Banksia Station Upgrade

Determination Report

September 2020

Figure 3 Key features of the Proposed Activity (indicative only, subject to detailed design)

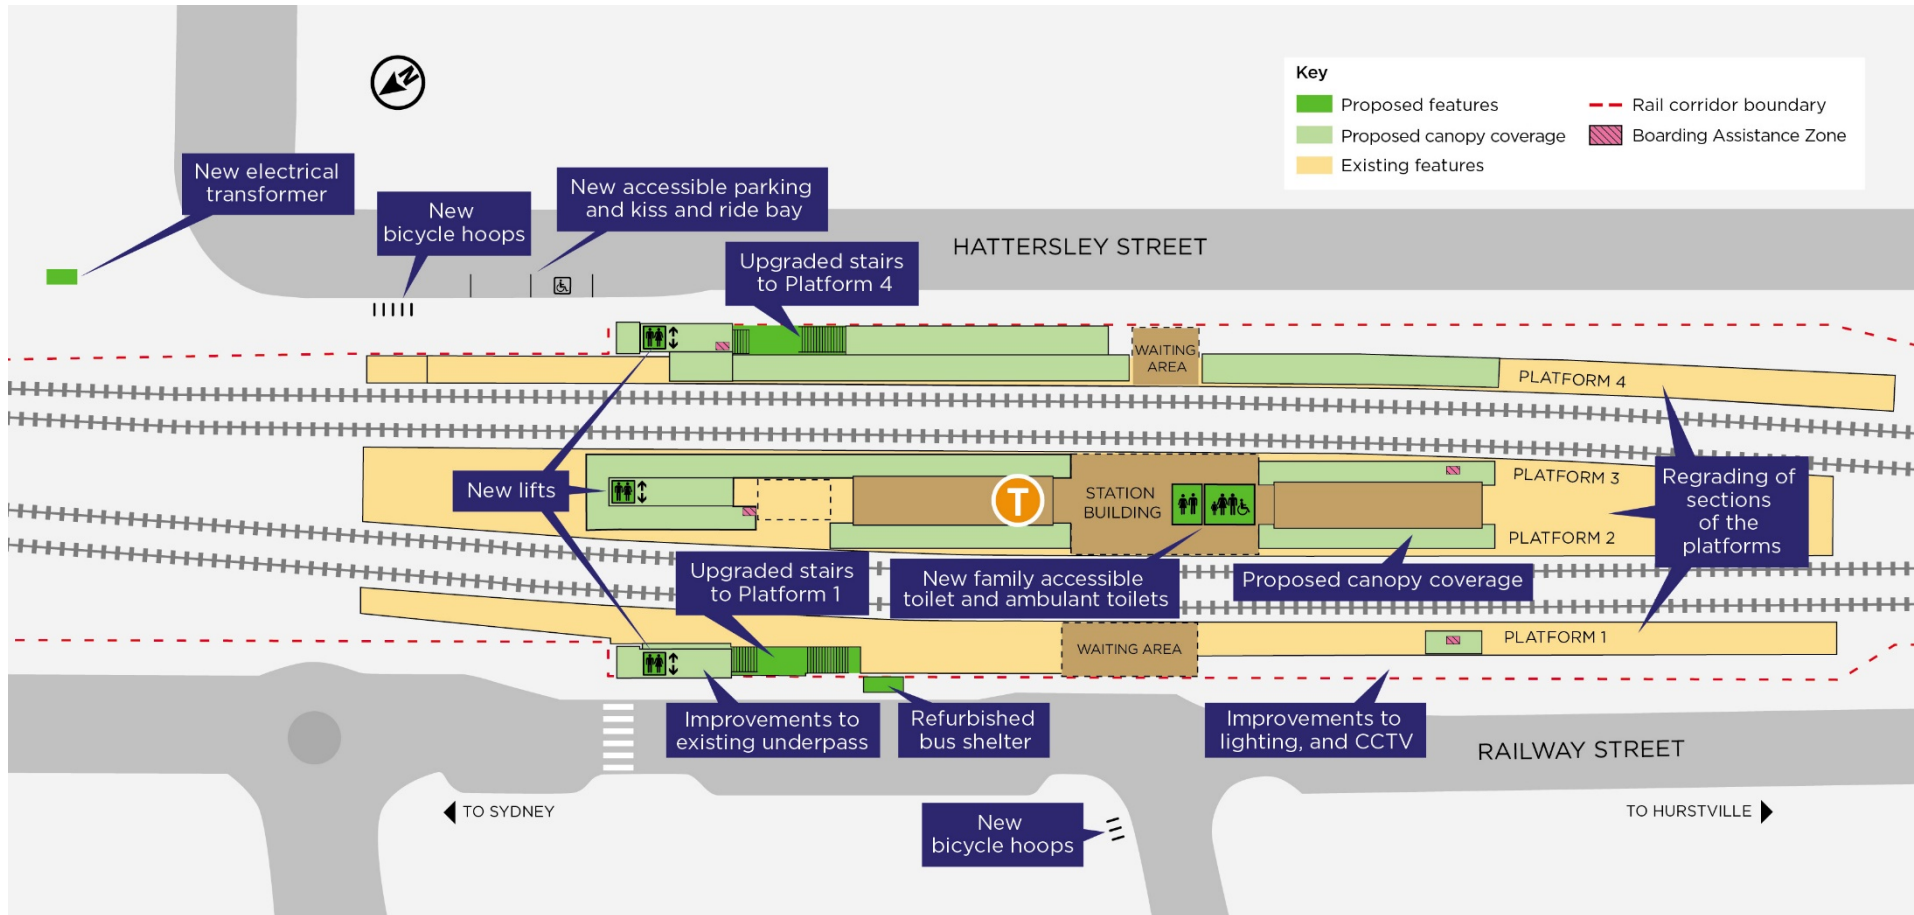
Aspect of the Proposed Activity	Design change	Discussion of impacts
Bicycle parking	Inclusion of three bicycle parking hoops on the corner of Railway Street and Bowmer Street as shown in Figure 3. These would be in addition to the four bicycle parking hoops proposed at the Hattersley Street entrance to the station to replace the existing bicycle parking rack at this location.	The Proposed Activity would result in an increase in the bicycle parking available within the station precinct and Banksia local centre as well as making bicycle parking available on both sides of the rail corridor at Banksia Station. Cyclists using the on-road local bicycle route along Railway Street would not need to cross the rail corridor to park their bicycle. This would make interchange between bicycle and train or bus easier. It would make it easier for people to cycle to the Banksia town centre.
Temporary construction site office	An existing retail space on the corner of Hattersley Street and Taylor Avenue would be temporarily used as a construction site office. A lease has been negotiated for the use of the portion of 309 Princes Highway that fronts Hattersley Street (refer to Figure 4). The site office would only be used for administrative purposes. It would be fitted out for use as an office and would include meeting spaces, desks and other office furniture and equipment. The site office would be used during standard working hours (7:00 am to 6:00 pm Monday to Friday; 8:00 am to 1:00 pm Saturday).	The proposed site office would be used by construction personnel who would otherwise need to be provided with office space and amenities in portable buildings. Reducing the number of portable buildings required for the Proposed Activity would reduce the visual impact associated with these buildings as well as the traffic and noise impacts associated with their delivery, installation, servicing and removal. The proposed site office is currently vacant. Leasing this building during the construction phase of the Proposed Activity would have economic benefits by increasing demand for local commercial space.
